## ADDENDUM NO. 1

Date: November 11, 2021

**Hobbs Middle School HVAC Replacement  
Shelley School District No. 60  
Shelley, Idaho**

MD1.30

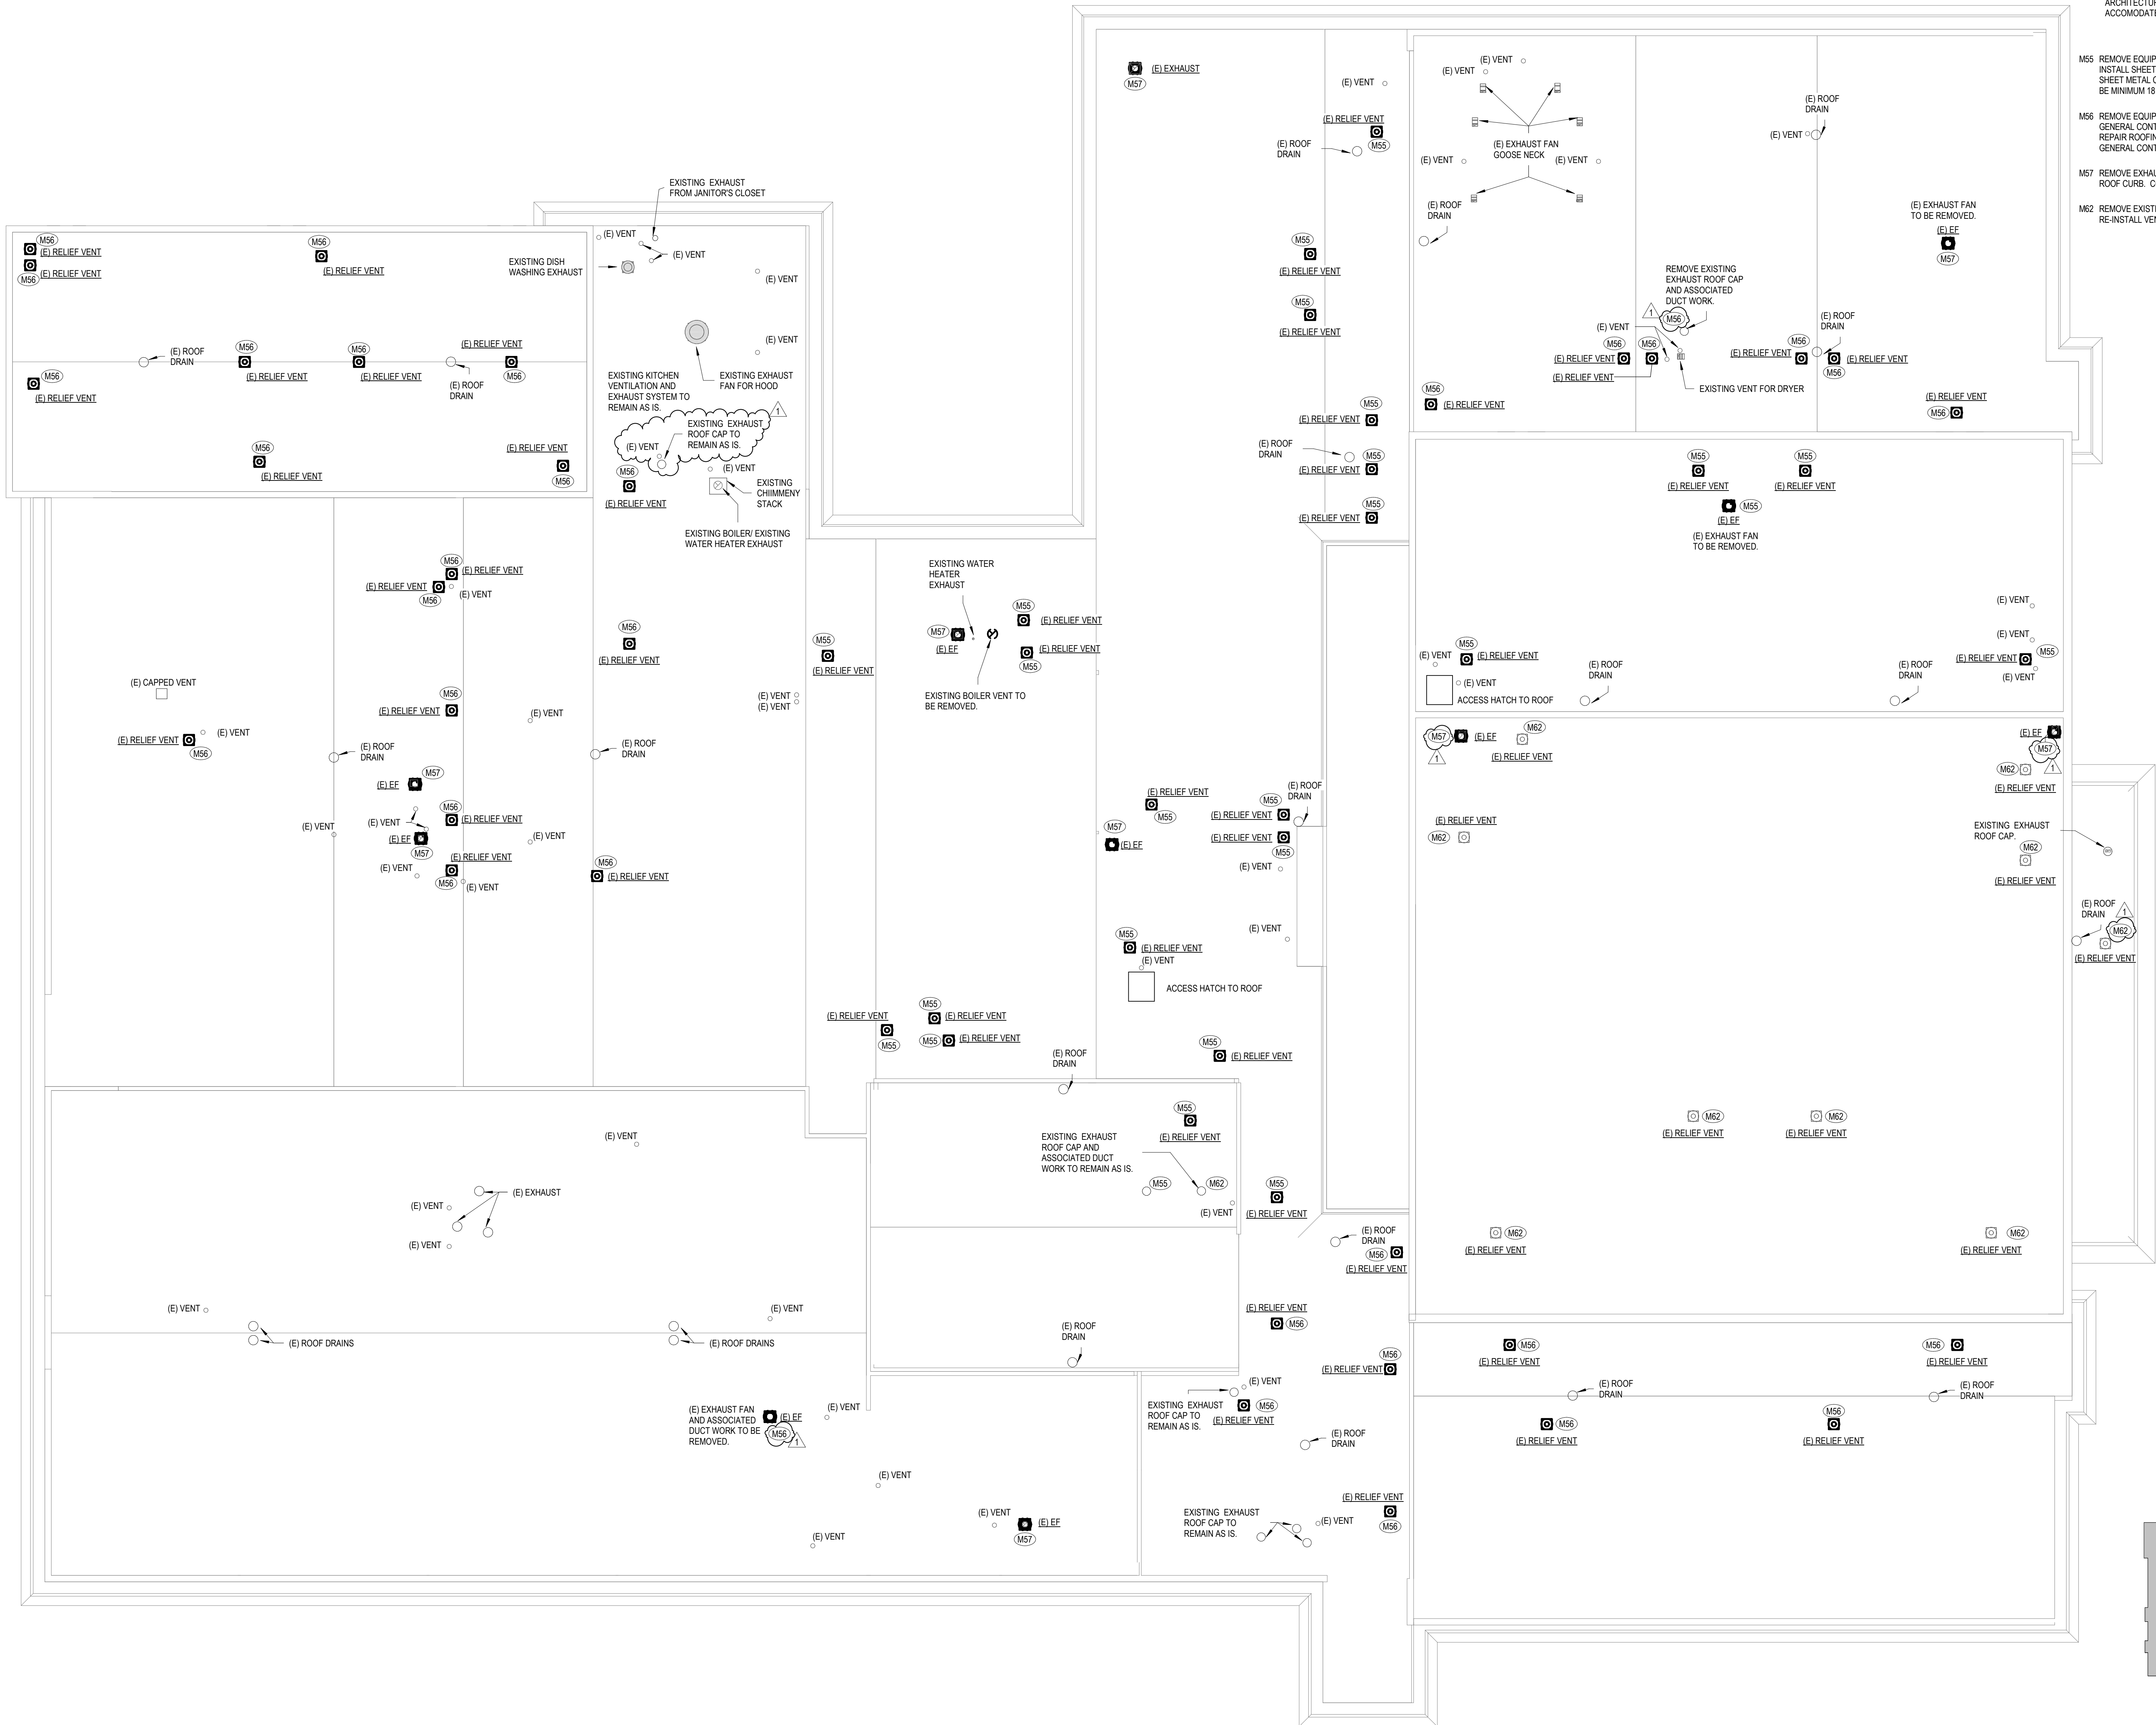
1. Sheets MD1.11-MD1.20. Keynote M50 to be applied to every wall penetration of duct that is to be removed.
2. Sheet MD1.13. There is existing ductwork serving the library return grilles in the existing dropped soffit that will require removal. Assume removal of 20"x20" duct connecting the two return grilles and extending into the corridor.
3. See revised Sheet MD1.30
  - a. Refer to clouded changes in the attached sheet.
4. See revised Sheets M1.00-M1.30
  - a. Refer to clouded changes in the attached sheets.

M2.12

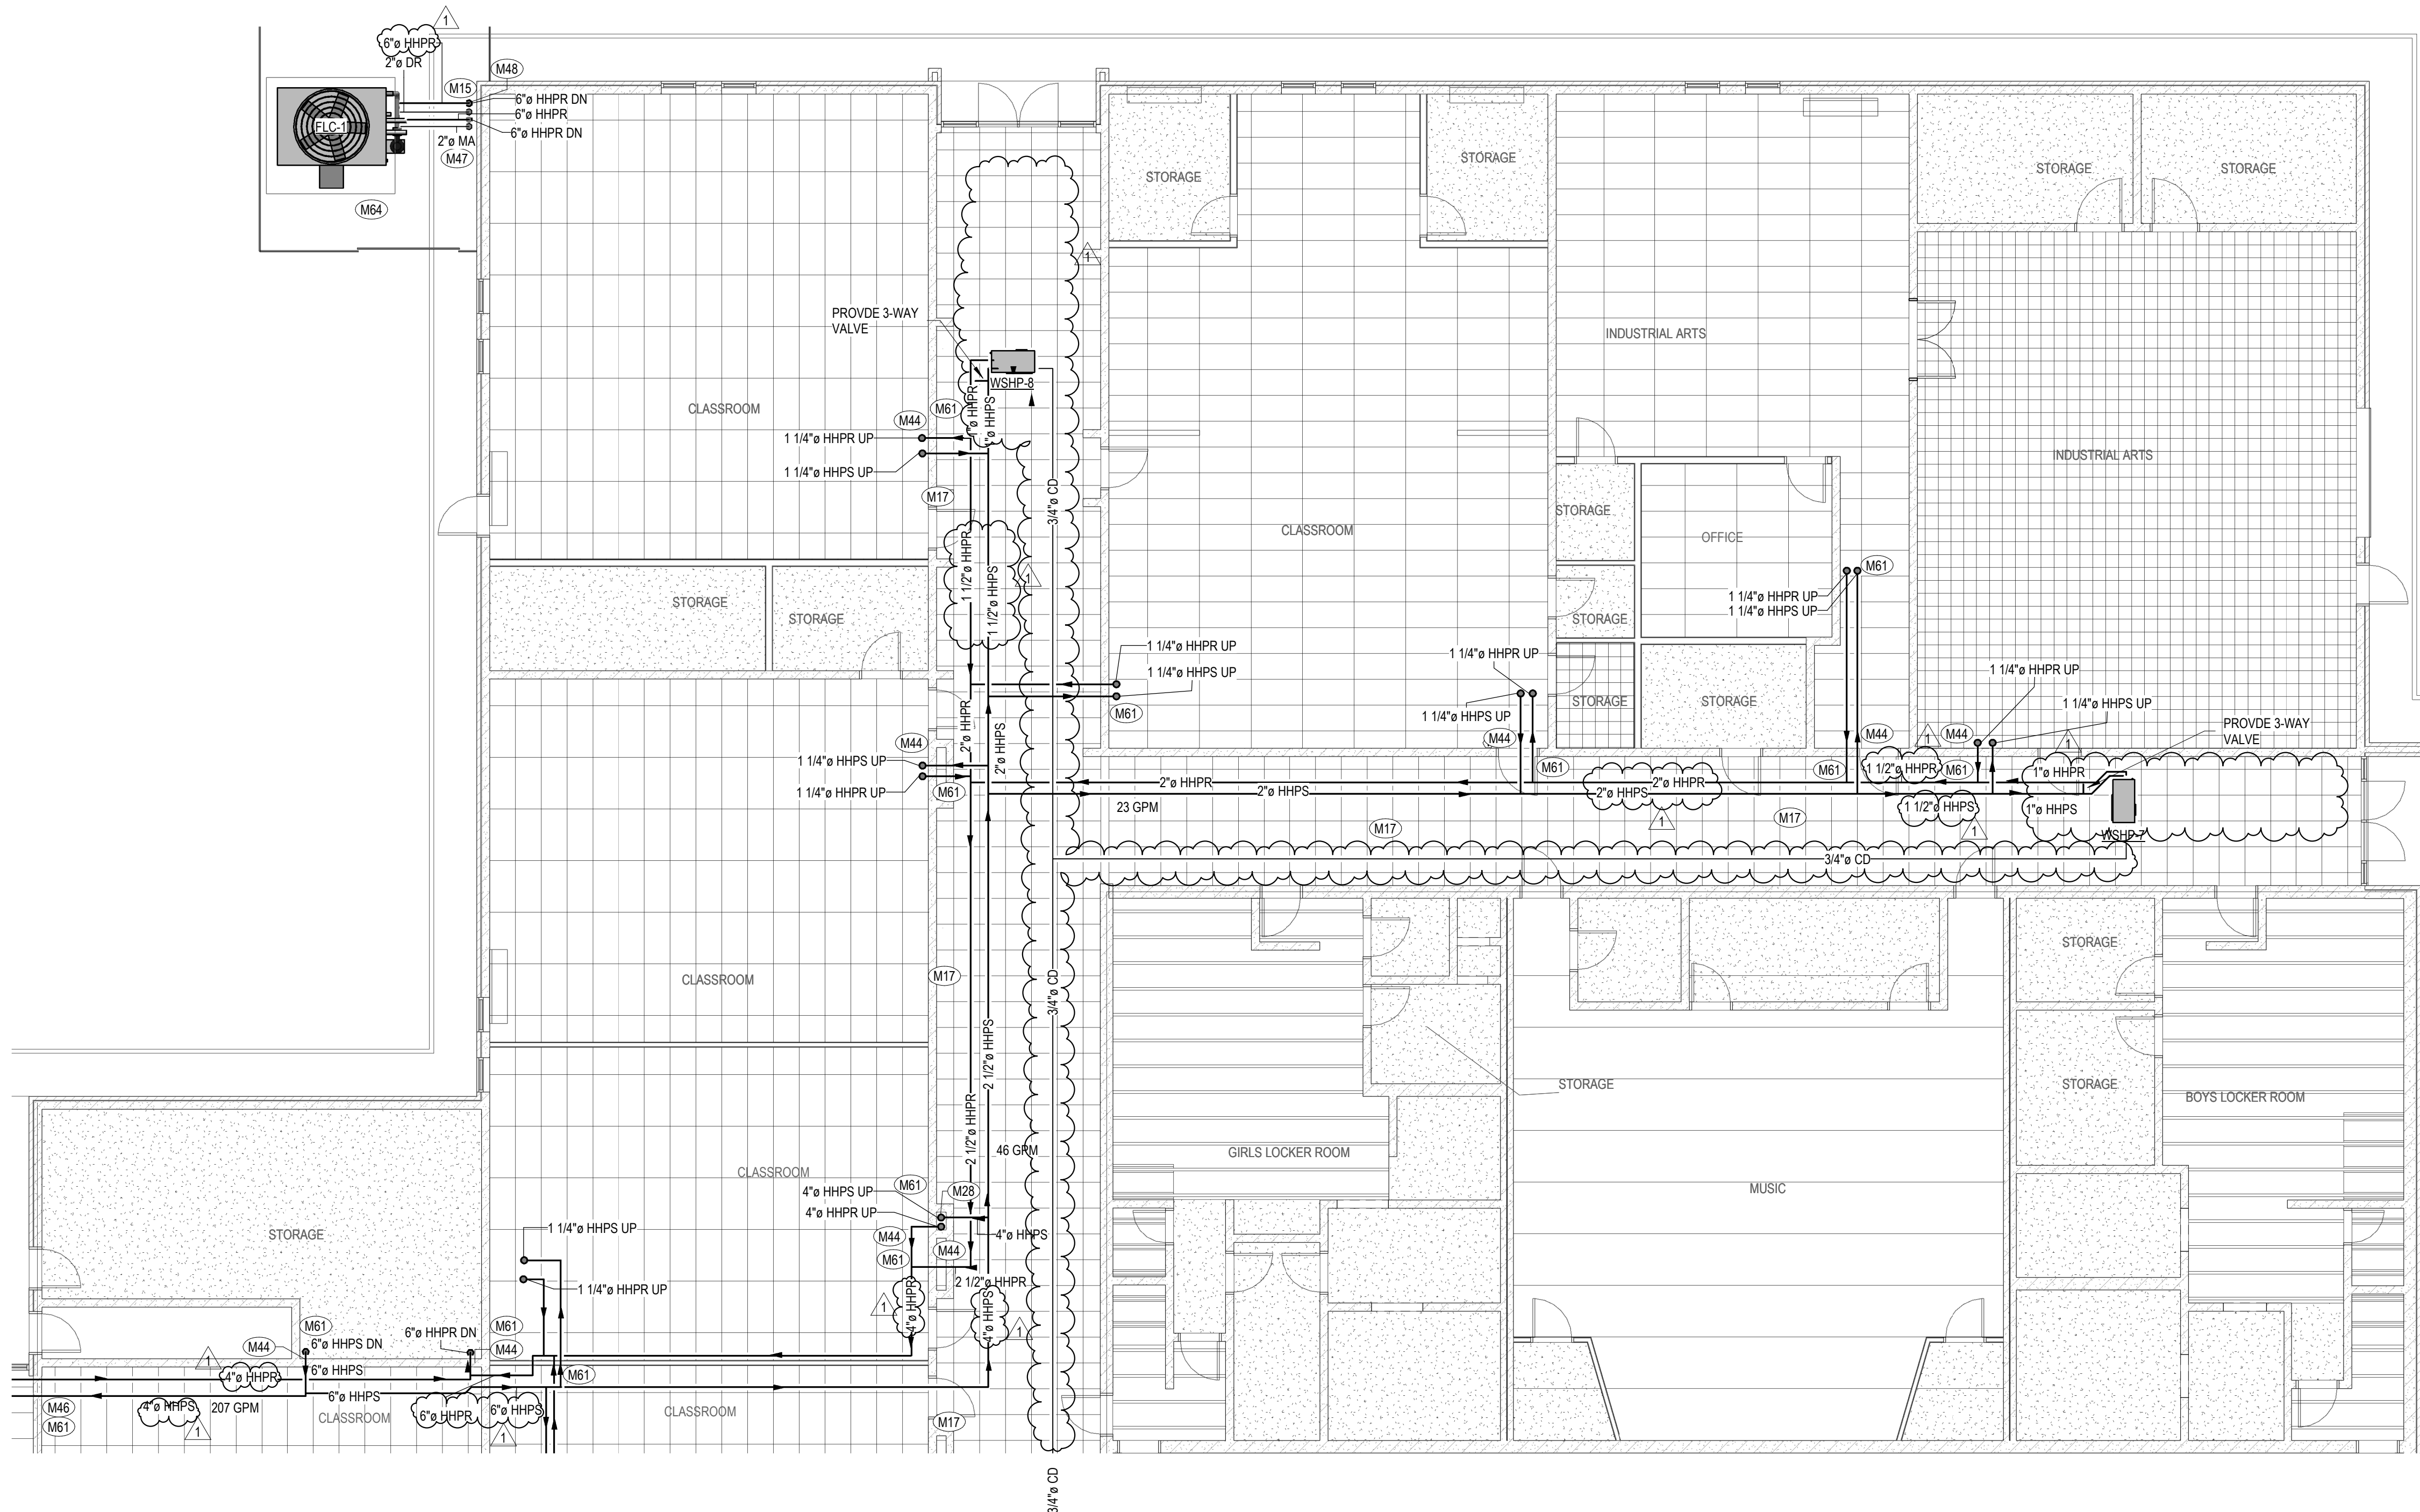
5. See revised Sheets M2.11-M2.20
  - a. Refer to clouded changes in the attached sheets.
6. See revised Sheet M6.10
  - a. Refer to clouded changes in the attached sheet.
